1975 F7-D

PARTS DIAGRAM

SWING ARM/SHOCK ABSORBERS ('71-'73 F7/F7)

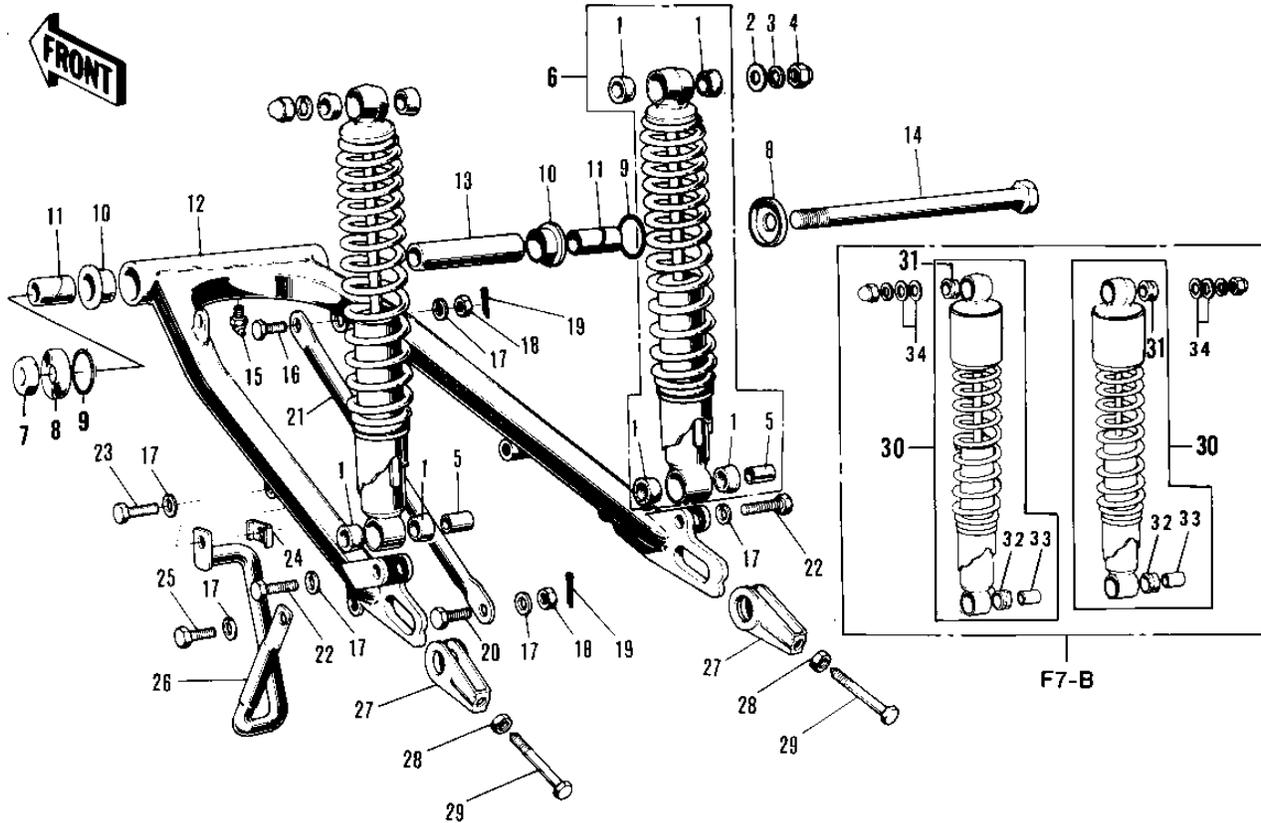
Ref. No. 27, Chain Adjuster		
	OLD	NEW
	1.6 mm 15.2 mm	3.2 mm 13.7 mm
Chain Adjuster	33041-041	33041-048
Collar	42032-027	42032-036
Frame No.	~20779	20780~
Interchange?	Use new parts as a set in place of old parts.
